Planning Commission

Regular Meeting Agenda

Frances Meaders Council Chambers
151 Willowbend Road
March 24, 2025 | 6:30 PM

SUBJECT: Conceptual Site Plan, Warehouse and Office, 1601 Moba Drive

NEW ELEVATION PROPOSAL

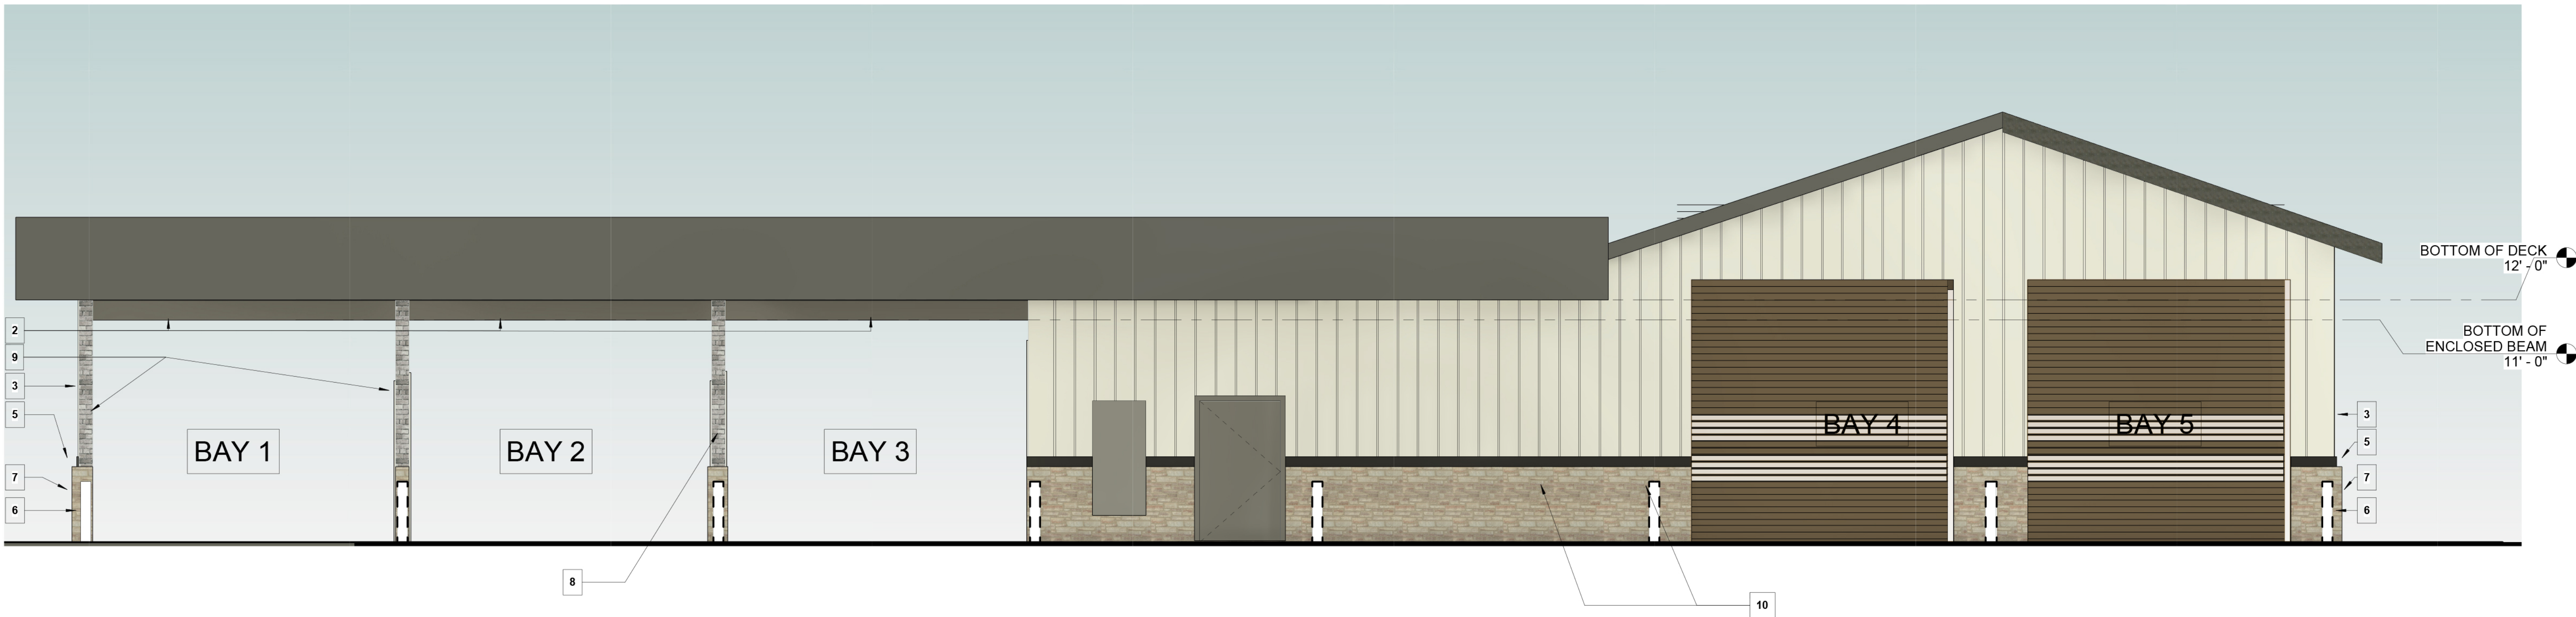
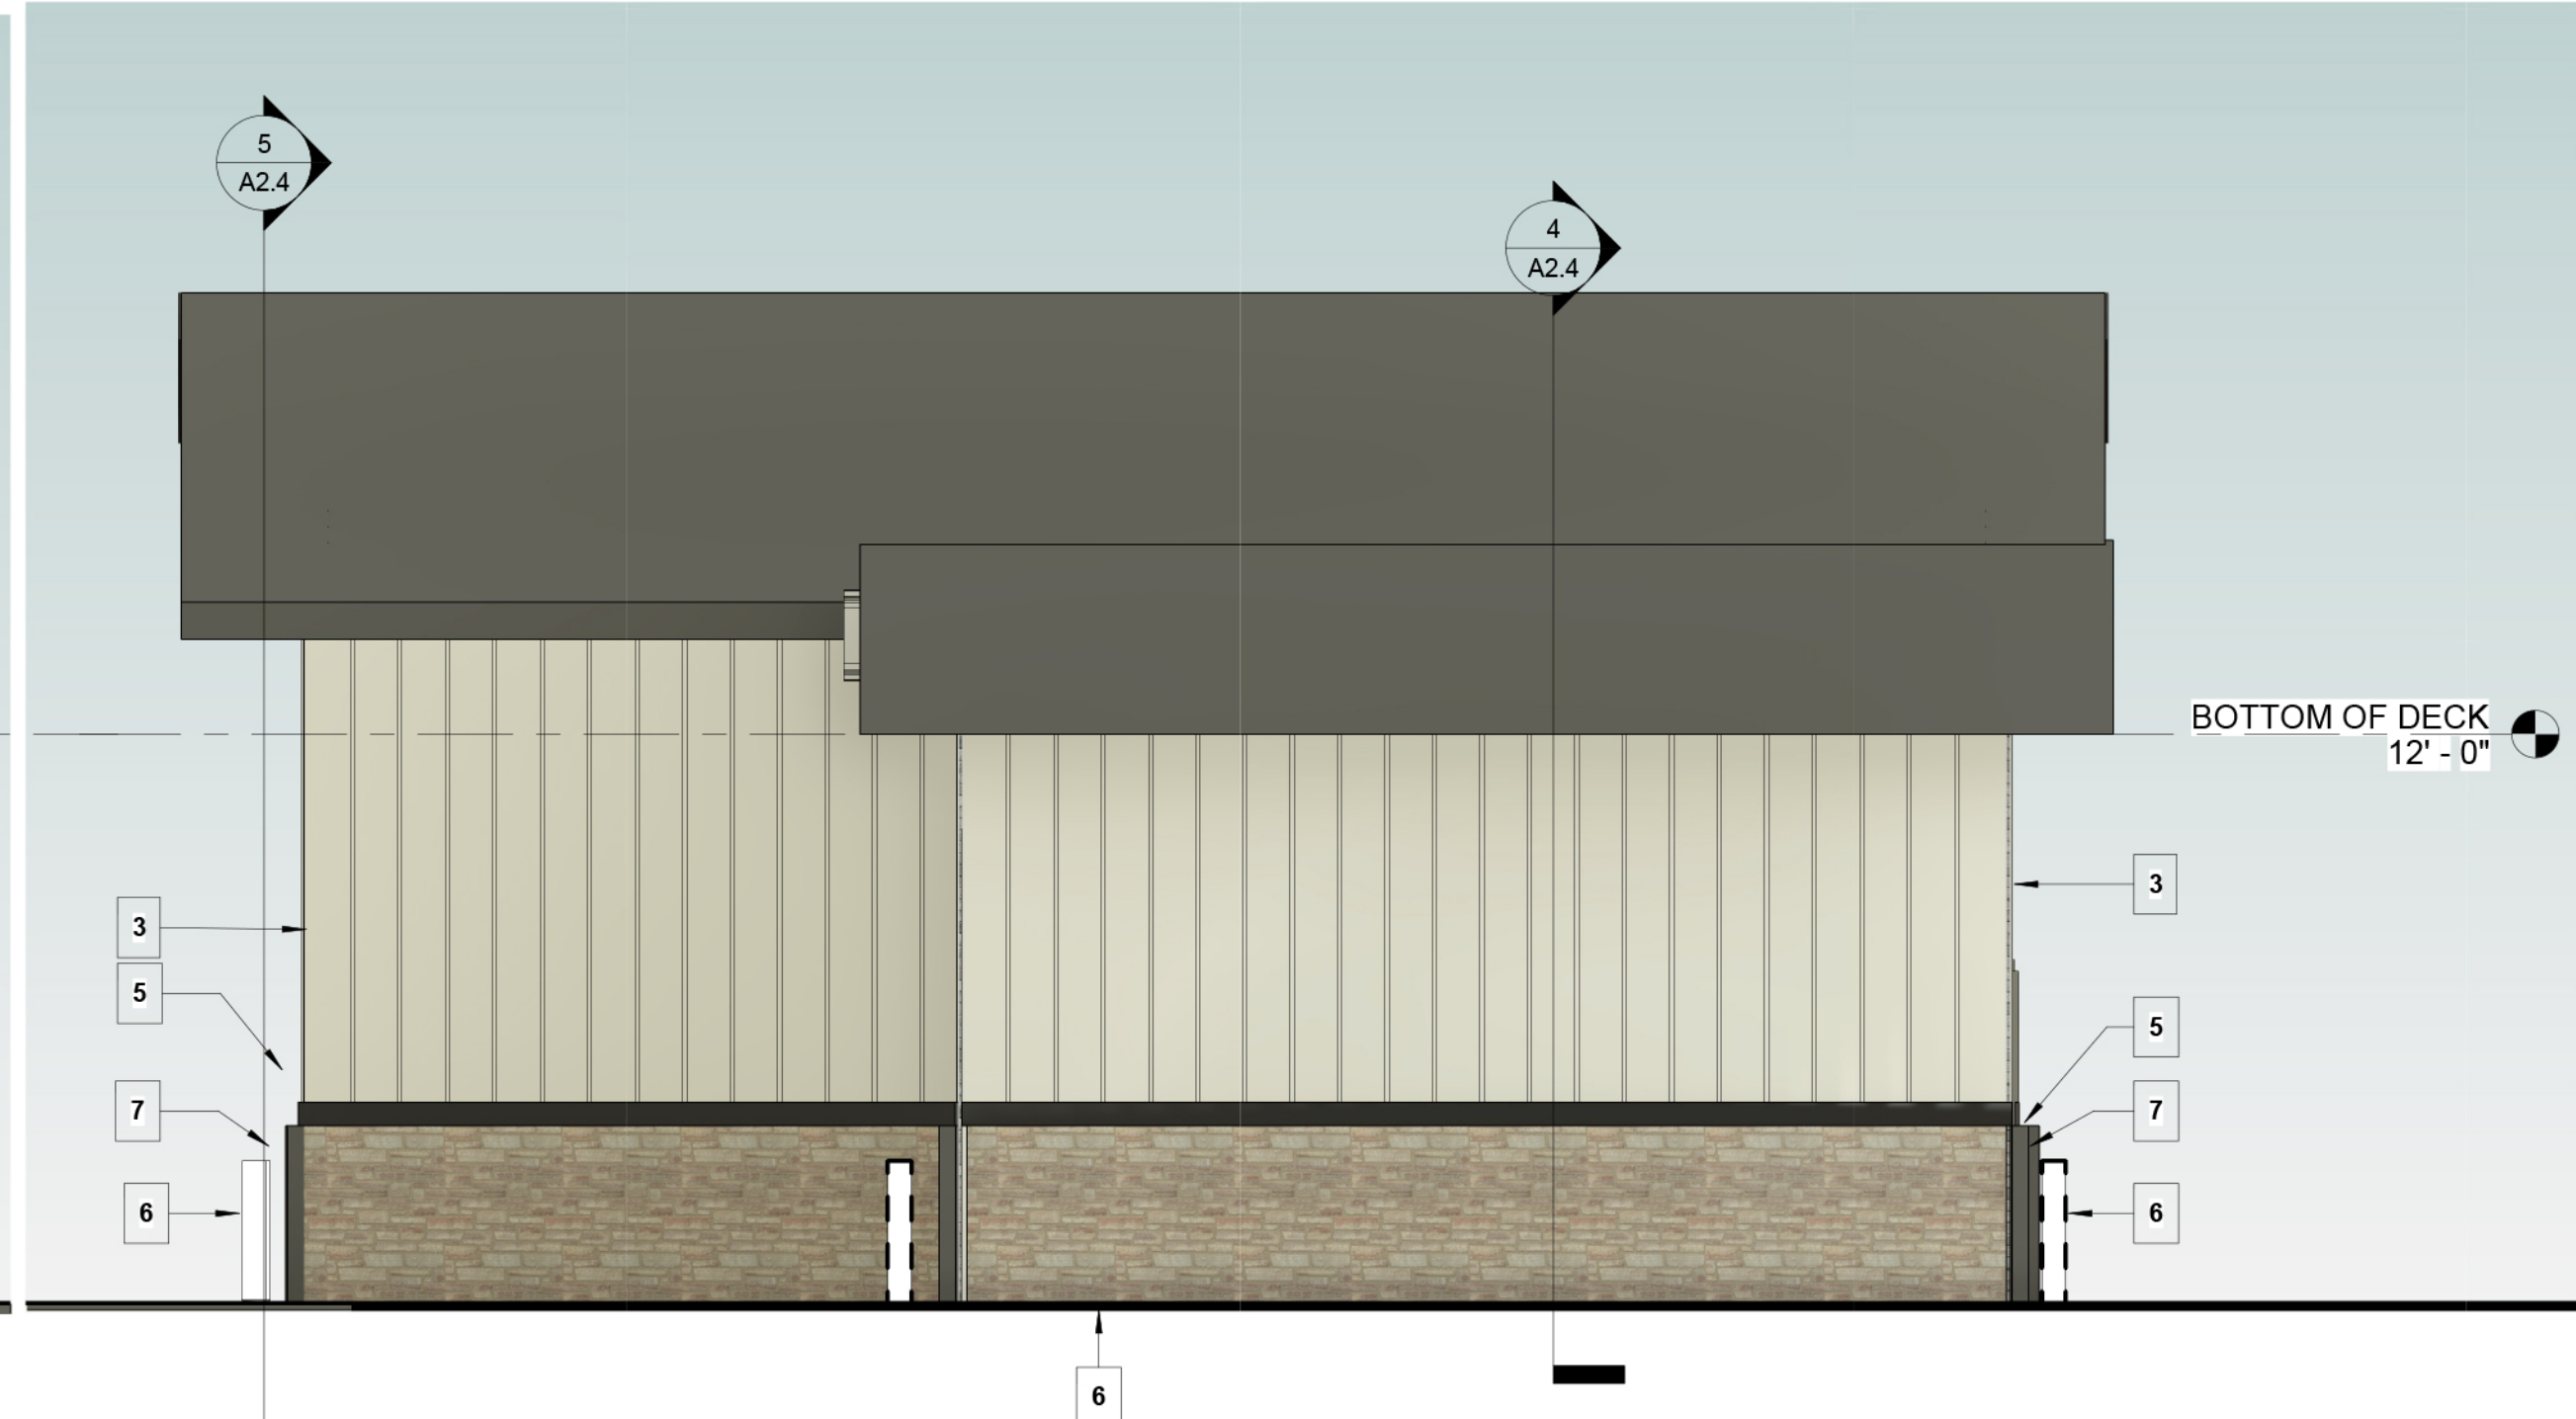
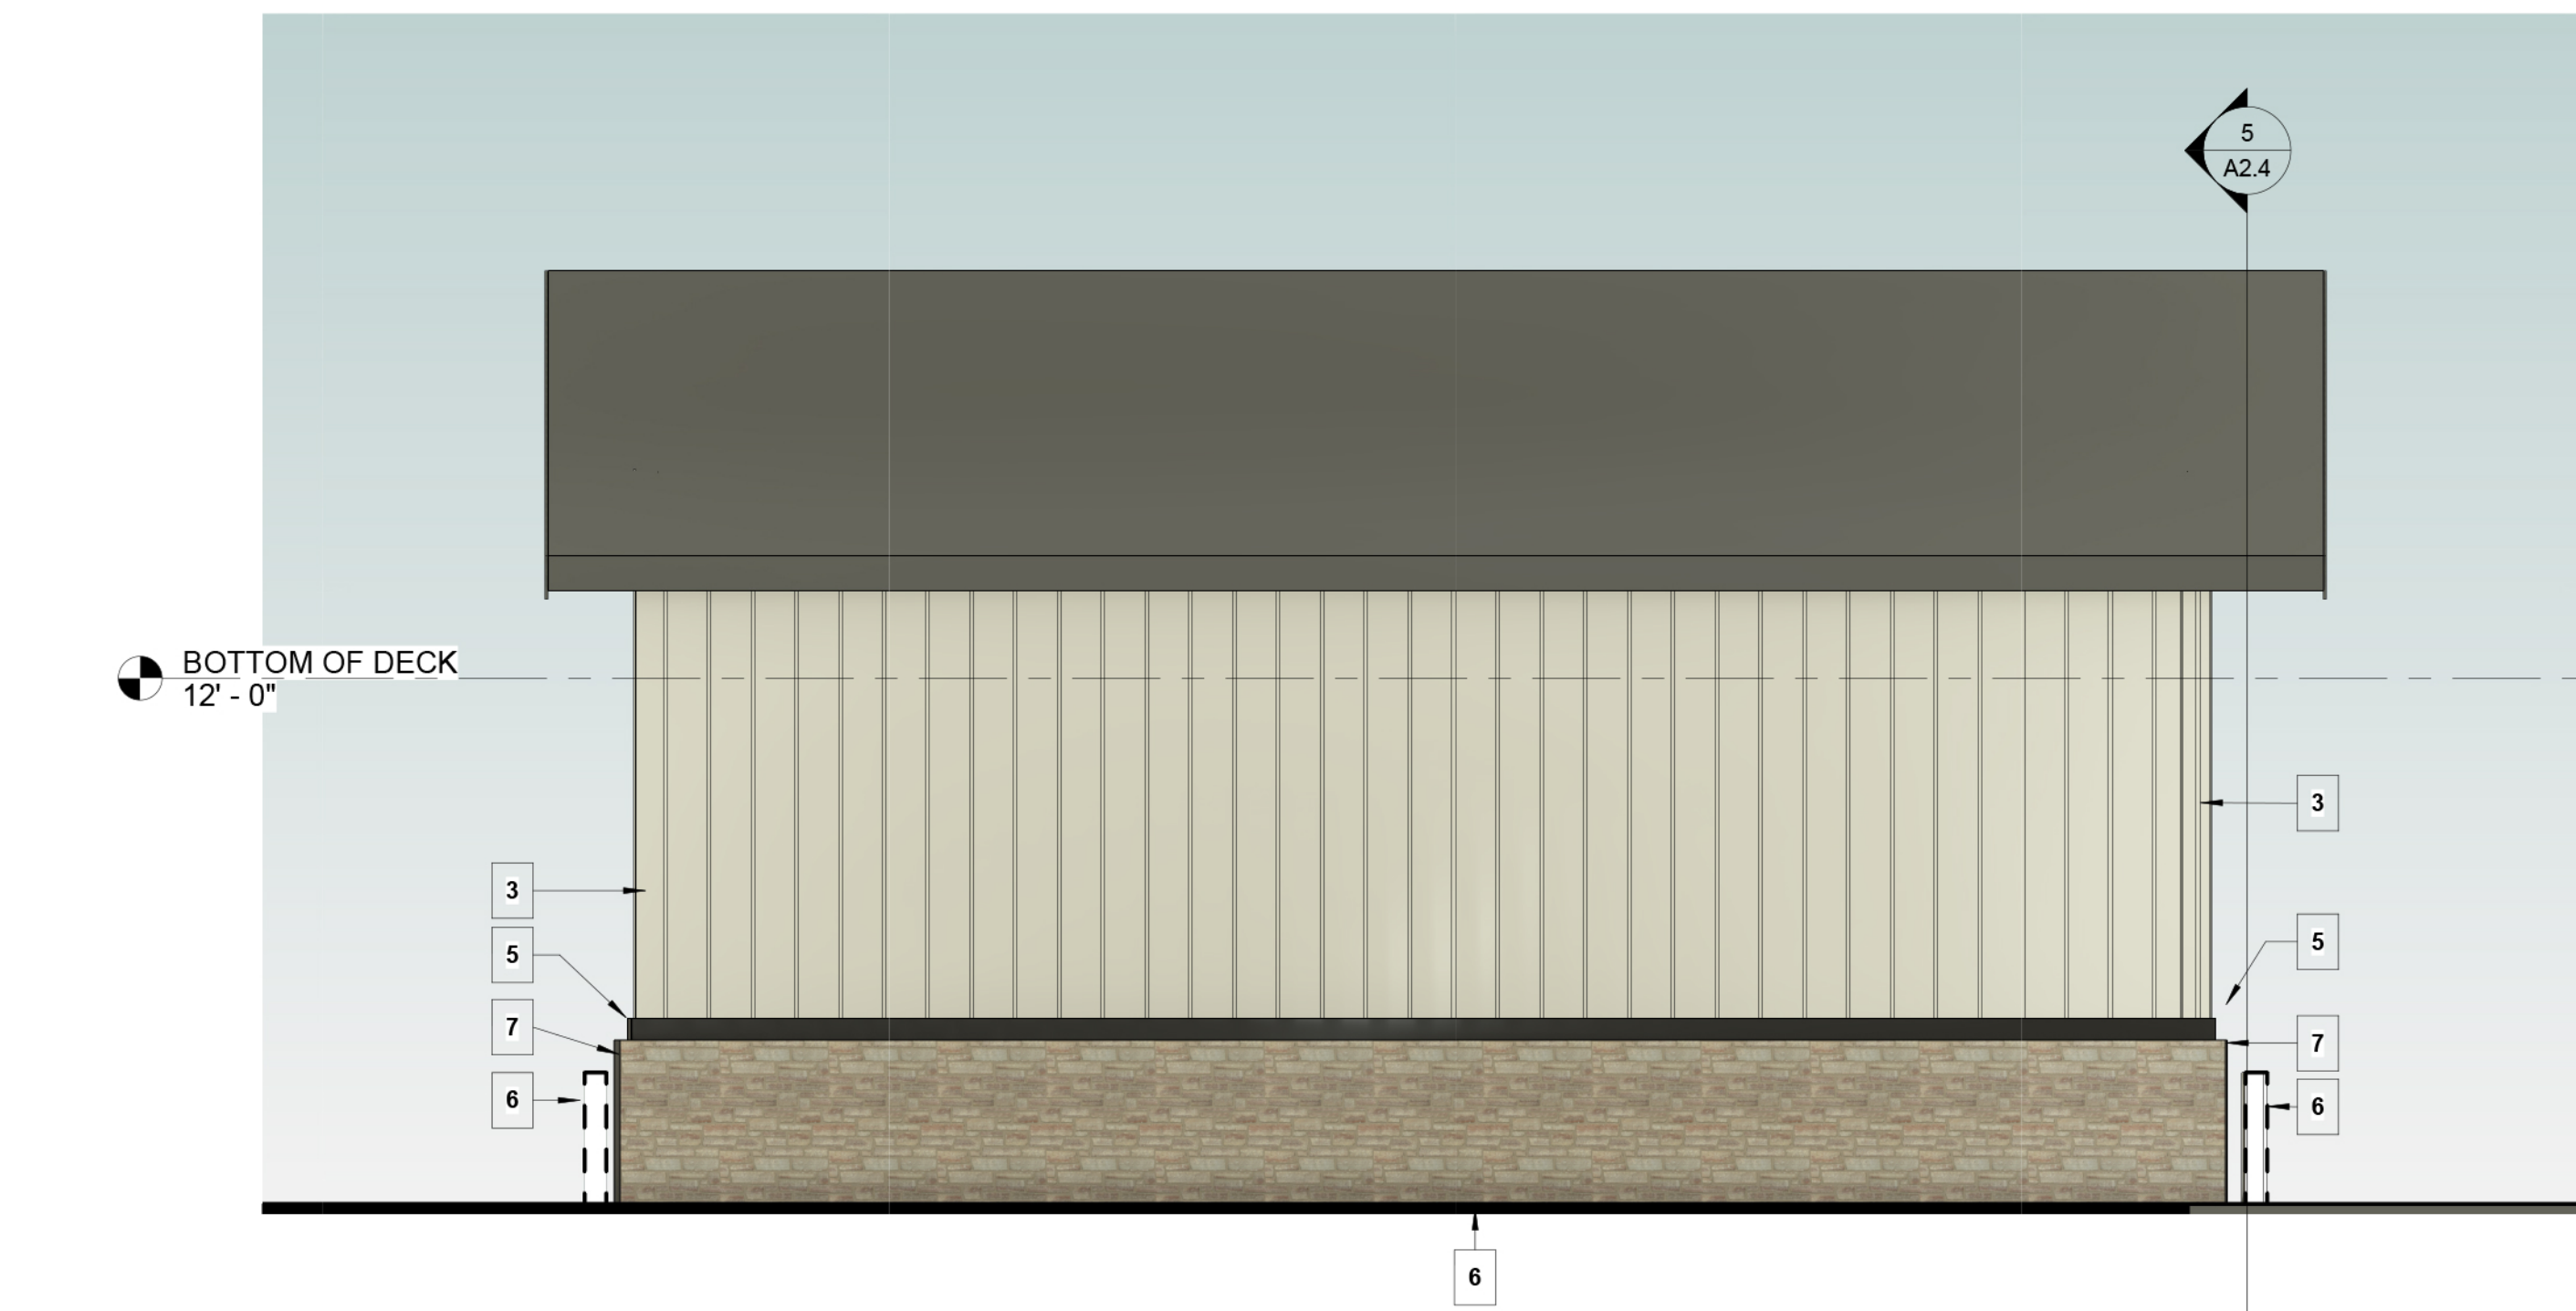
While the proposal to upgrade the car wash satisfies the majority of the City's design standards and enhances the visual appearance of the community, section 728 of the Land Development Ordinance states that natural brick "should" not be painted.

As a general rule, front facades should be 80% primary materials and side facades 50% primary materials. Technically, the site has two fronts. Shifting the automatic wash bays to the end cap and fully enclosing them has increased the amount of primary materials. The facade facing Stevens Entry is made up of 58% primary materials, the west side facing Prime Pt. is 100%, and the east side 81%. Staff feels Hardi board is a quality durable material and meets the intent of the ordinance for primary materials.
